307-12-04
July 11, 2013

Re: CEMEX South Cement Plant Alternative Fuel/Material Processing Facility
Pending Permit #22787-004-SO/31
WACS: 40778, Brooksville, Hernando County, Florida

On behalf of CEMEX Construction Materials Florida, LLC (CEMEX) Koogler and Associates, Inc. (Koogler) is responding to the Department's request for additional information (RAI) dated April 24, 2013. The RAI items and our responses are as follows:

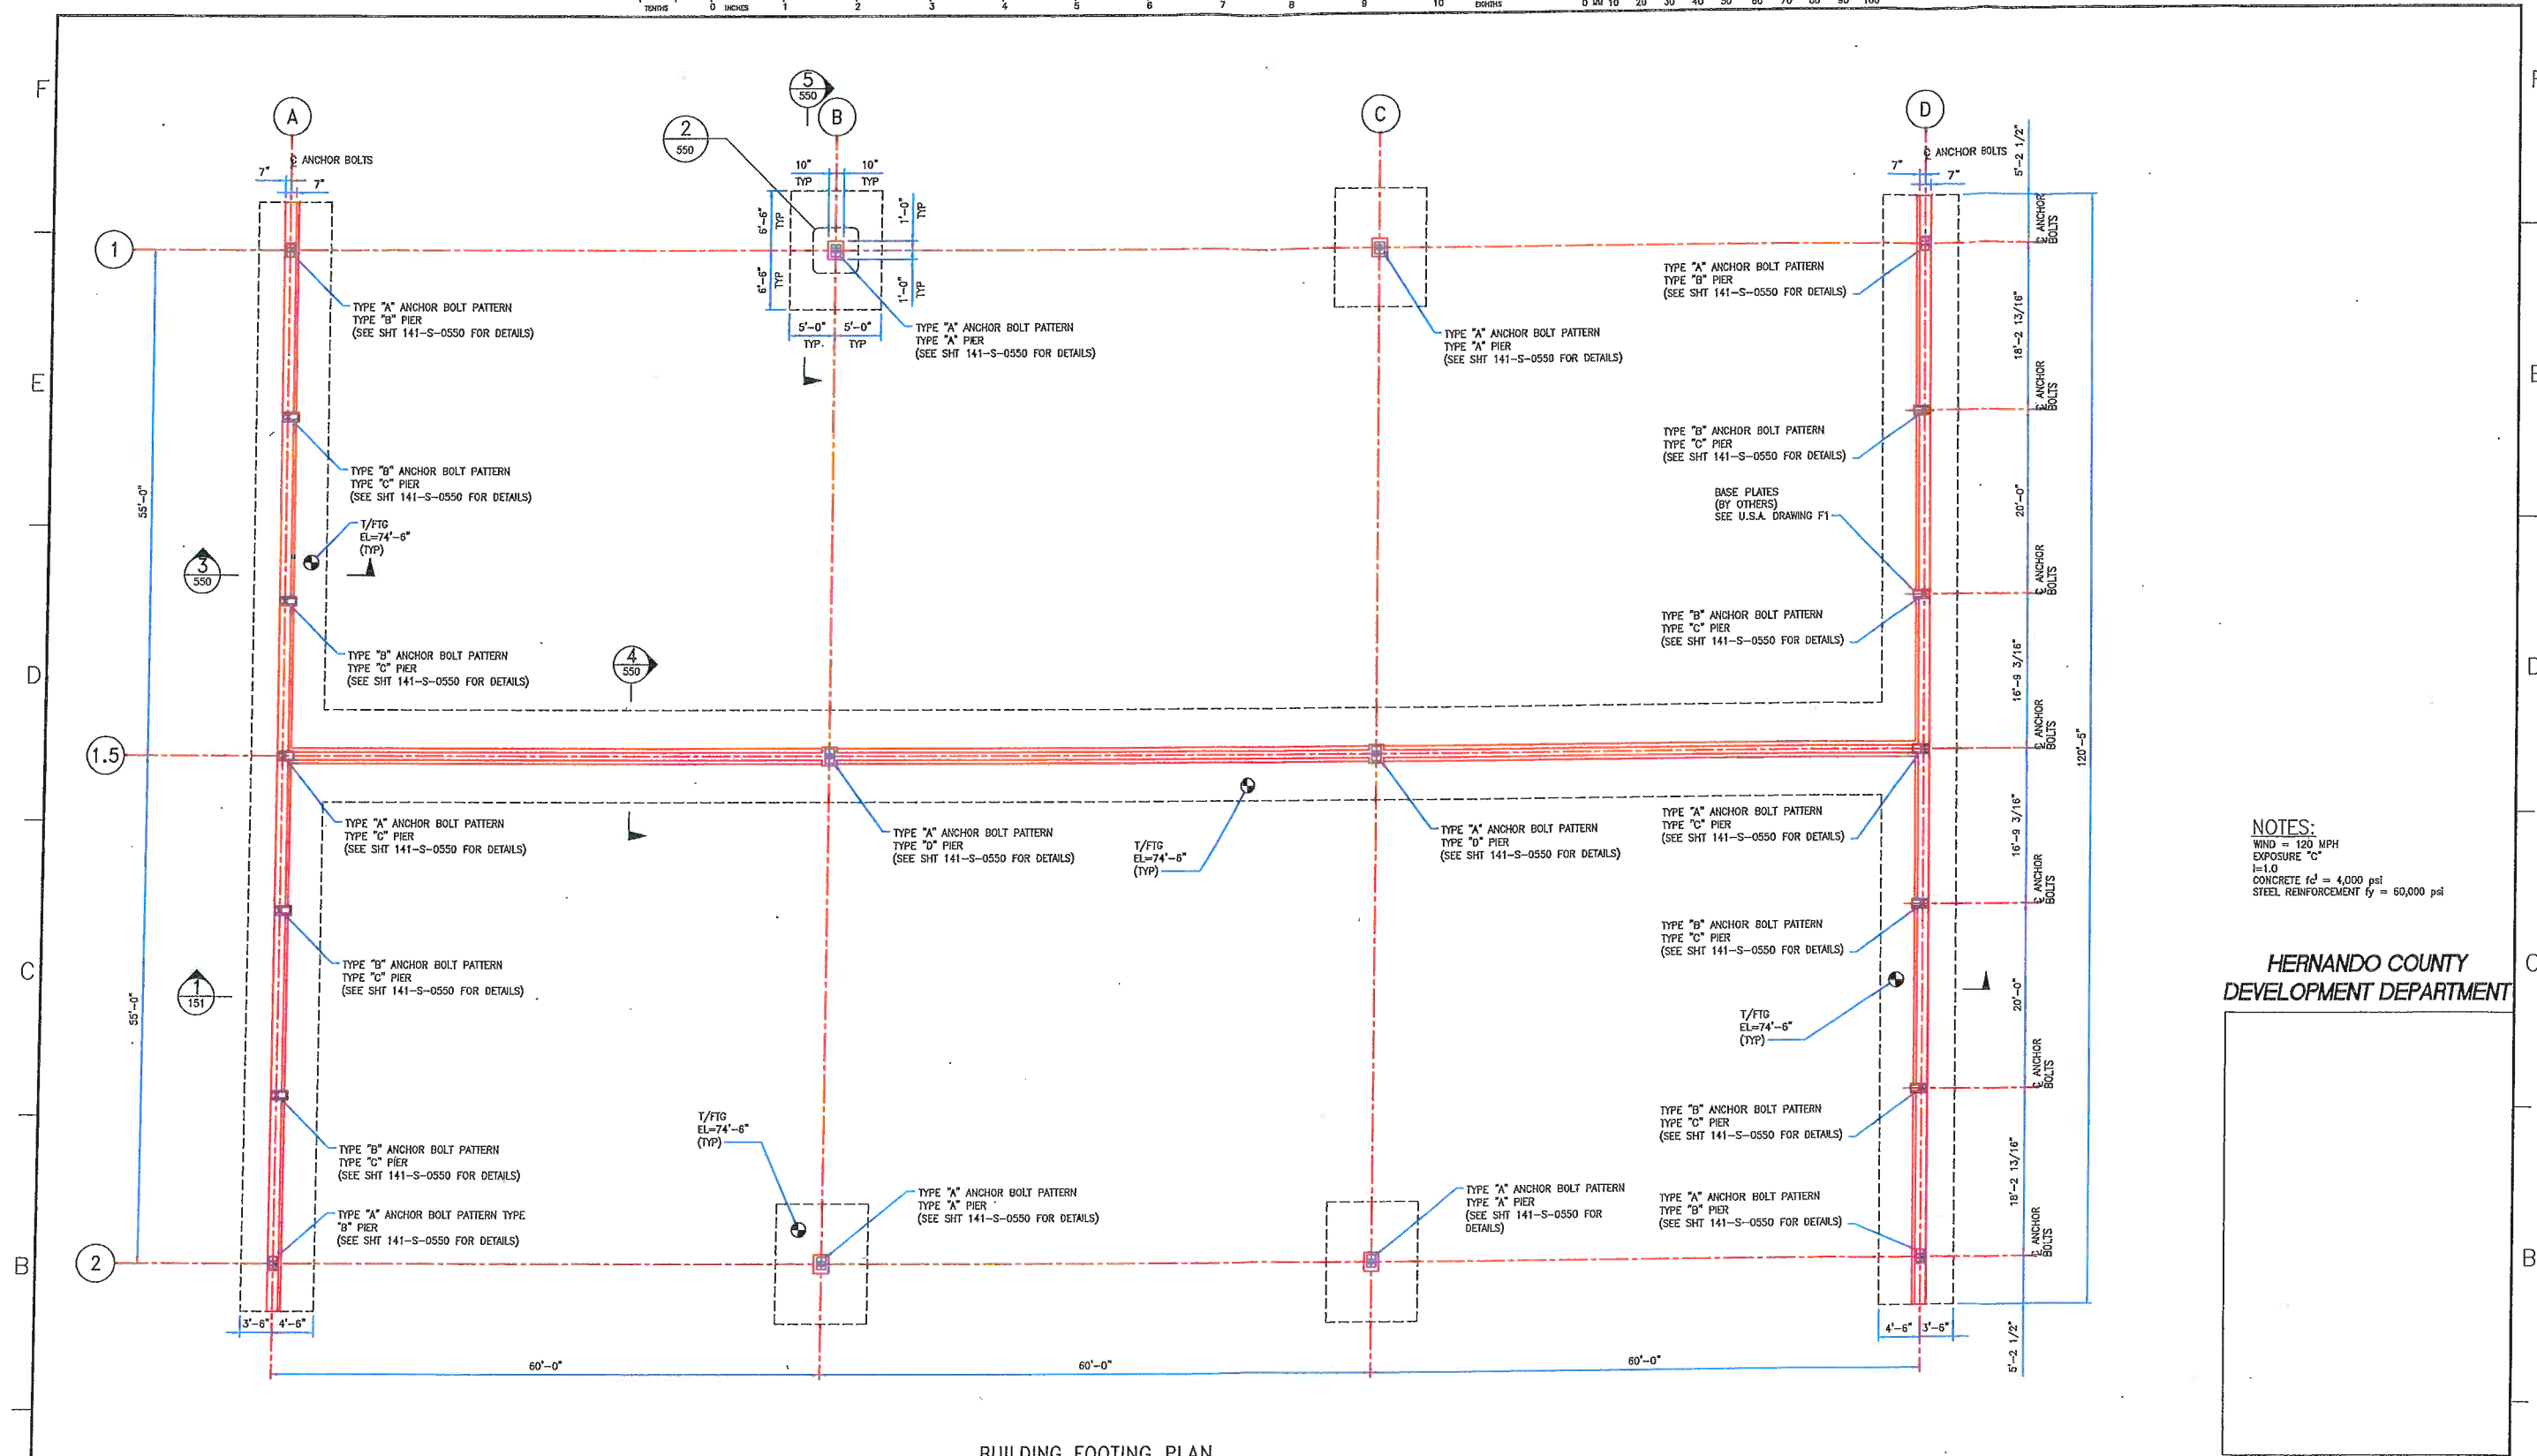
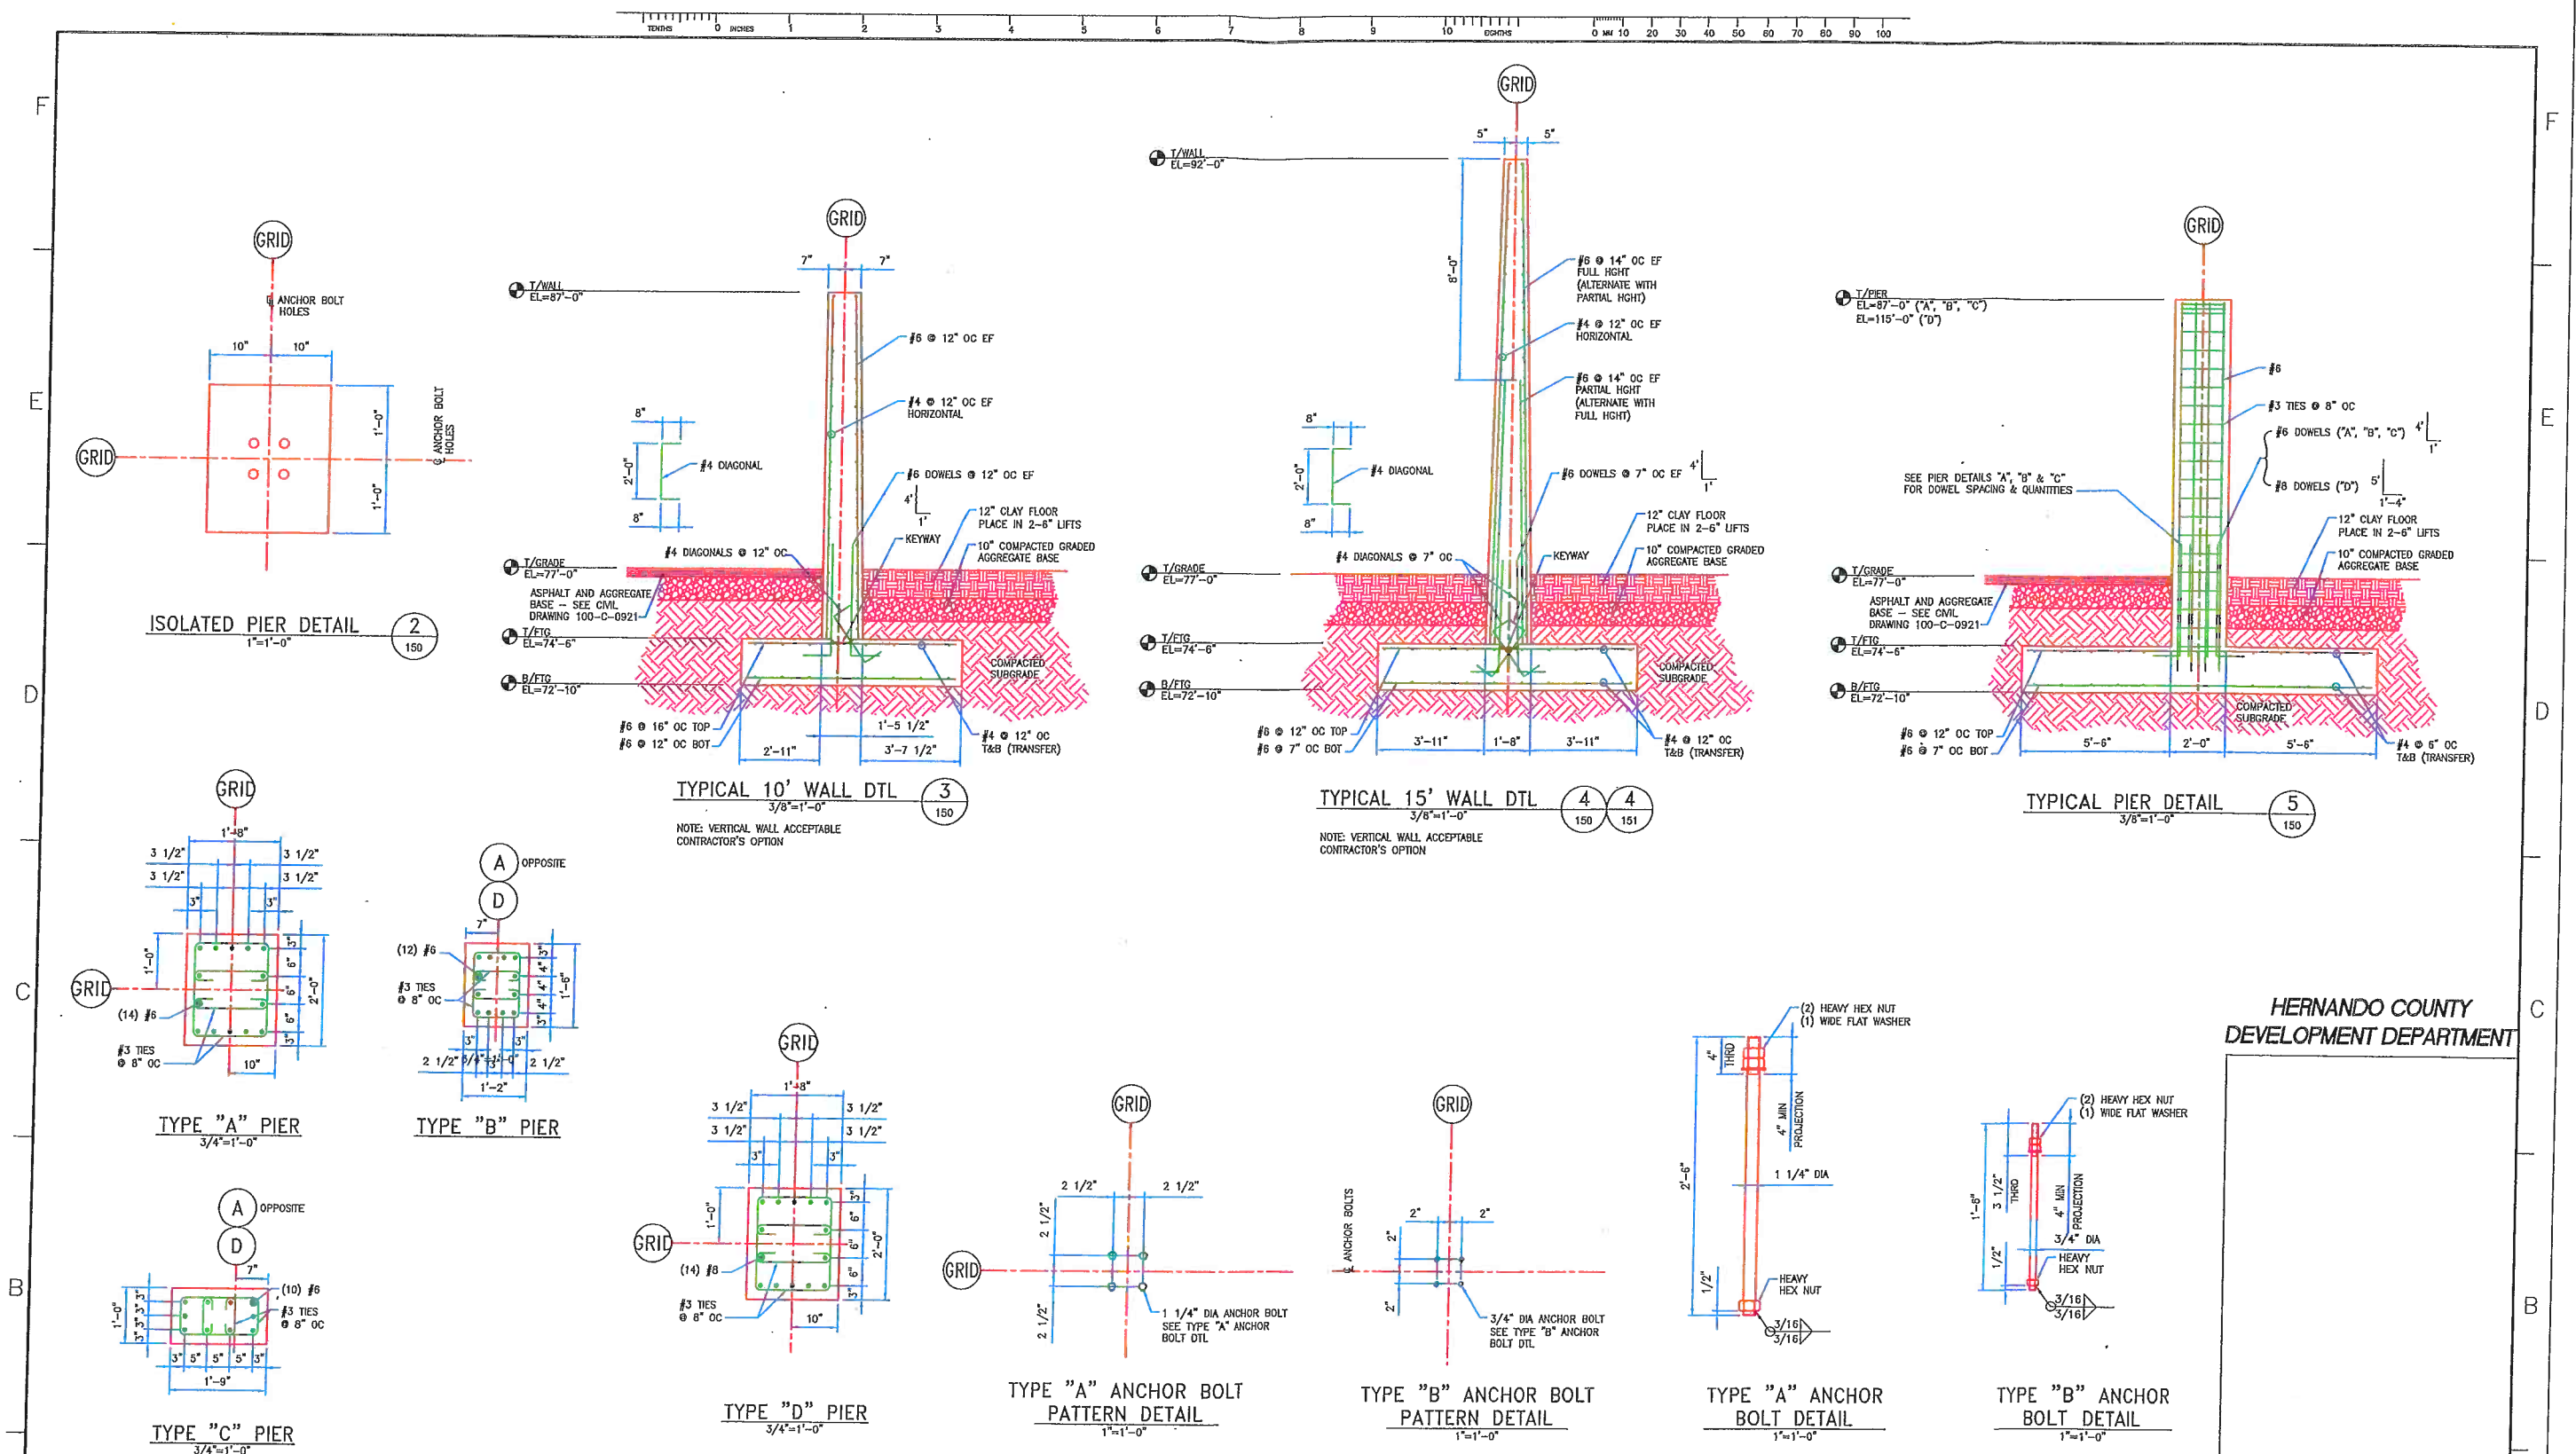
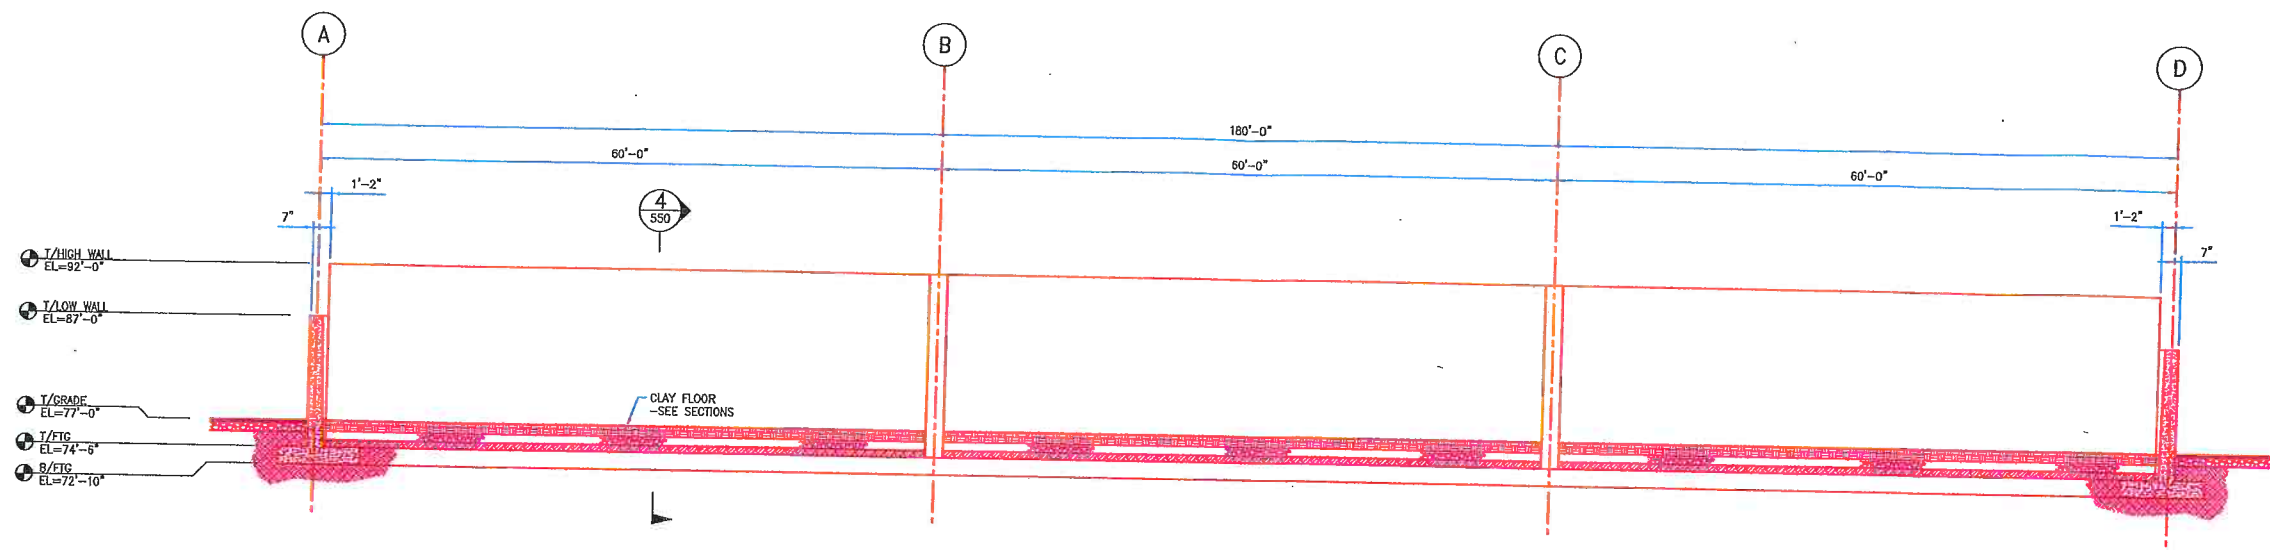
a. "the drawing provided in Attachment 5 does not appear to be as-built drawings. Please either provide as-built drawings or provide verification that they are representative of as-built conditions."

b. "Please verify whether hydraulic conductivity information on the installed clay layer is available and provide this information as applicable. In the absence of this information and taking in consideration the typical wear and damage to clay floors described in Comment #1.a.(2) above, please provide supporting justification for assuming that the floor in the ASB building is comparable to the A-Frame building floor and that representative borings of the floor and vertical permeability testing was not necessary to demonstrate the existing floor is as constructed and impermeable."

Response: A response from George Townsend, CEMEX Environmental Manager, stating that the drawings provided are representative of as-built conditions is attached.

Response: According to George Townsend, Environmental Manager with CEMEX, FDEP required and approved the installation of a geomembrane (clay liner) in the floor of the ASB Building. Cindy Falandyz of the FDEP was reported as conducting a site inspection during the time of construction and took photographs. This information is on file at the Department and CEMEX will search their records and provide copies of correspondence and documentation under separate cover.

The drawings of the ASB Building provided in Attachment 5 of the RAI Response from Koogler and Associates, Inc., dated March 27, 2013 are representative of as-built conditions.
